Model: Model J-P3		Date: 14-May-04	No.: RG106001
Subject: The menu key cannot be used		Prepared by: H.Taguchi	
From: 1st Tech. Support Sec. Service Support Dept.			
Classification:	<input checked="" type="checkbox"/> Troubleshooting	<input type="checkbox"/> Part information	<input type="checkbox"/> Action required
	<input type="checkbox"/> Mechanical	<input type="checkbox"/> Electrical	<input type="checkbox"/> Service manual revision
	<input type="checkbox"/> Paper path	<input type="checkbox"/> Transmit/receive	<input type="checkbox"/> Retrofit information
	<input type="checkbox"/> Other ()

Model: Model J-P3		Date: 20-May-04	No.: RG106003
Subject: Vertical black lines		Prepared by: H.Taguchi	
From: 1st Tech. Support Sec. Service Support Dept.			
Classification:	<input checked="" type="checkbox"/> Troubleshooting	<input type="checkbox"/> Part information	<input type="checkbox"/> Action required
	<input type="checkbox"/> Mechanical	<input type="checkbox"/> Electrical	<input type="checkbox"/> Service manual revision
	<input type="checkbox"/> Paper path	<input type="checkbox"/> Transmit/receive	<input type="checkbox"/> Retrofit information
	<input type="checkbox"/> Other ()

Model: Mo

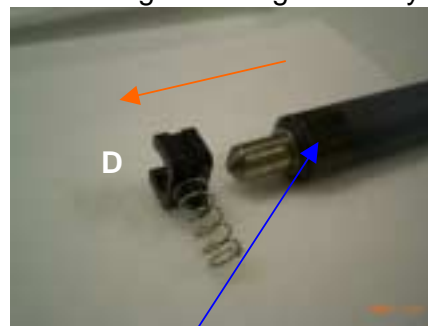
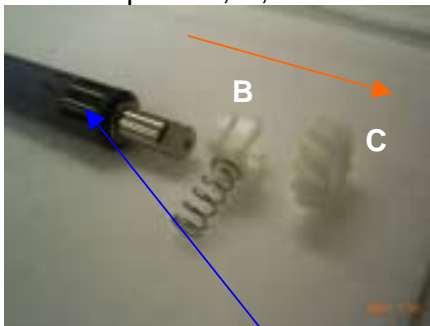
7. Remove the charge roller from the frame along with plastic components B, C, and D shown below, being sure to touch only the tape-covered rubber edges of the roller (see the photo in Step 9 below).

Note: Do not touch the cleaning blade or exposed rubber surfaces of the charge roller.

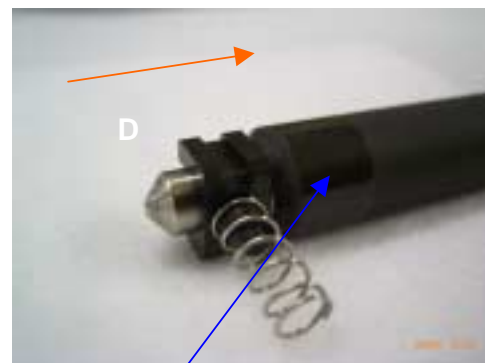
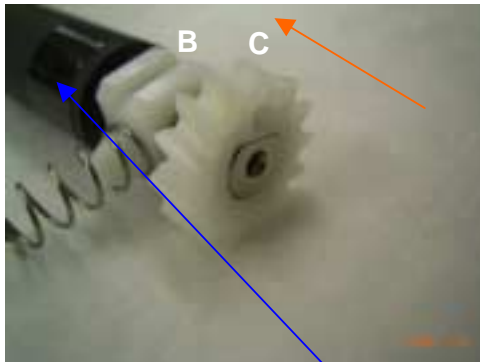
10. Clean the charge roller surface with a new cloth while holding the roller by its metallic edges.

11. Clean the charger roller with alcohol.

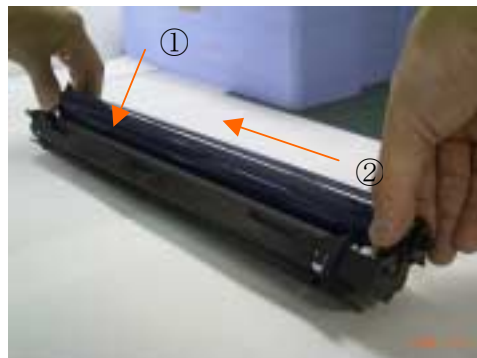
Note: Before proceeding to the next step:

- Make sure to attach the charge roller as shown below, i.e. parts B and D should both fit into their respective guide ribs on the unit frame.
- Make sure that: 1) the spring is properly aligned (straight; not bent), 2) the gears on both sides are attached properly to the shaft, and 3) the charge roller cleaner is properly secured in its bushings at both ends.

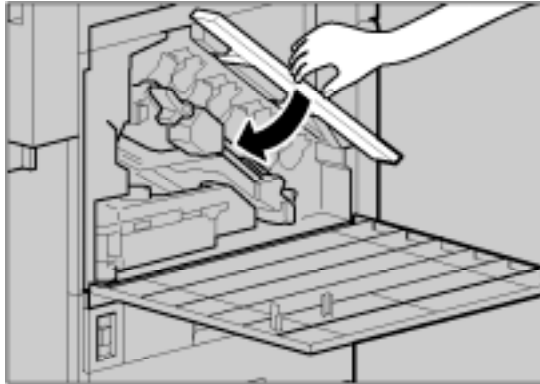
1. Turn the transfer belt release lever counterclockwise.

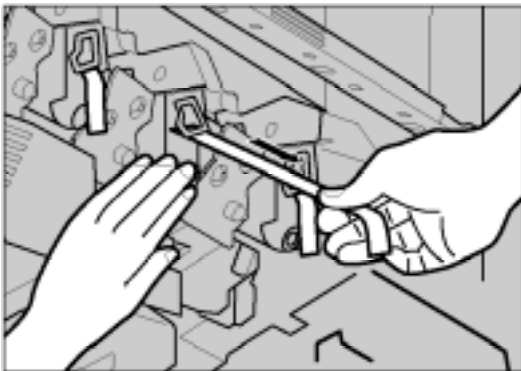
2. Loosen the two screws on the drum plate.
3. Open the drum plate until you hear a click.
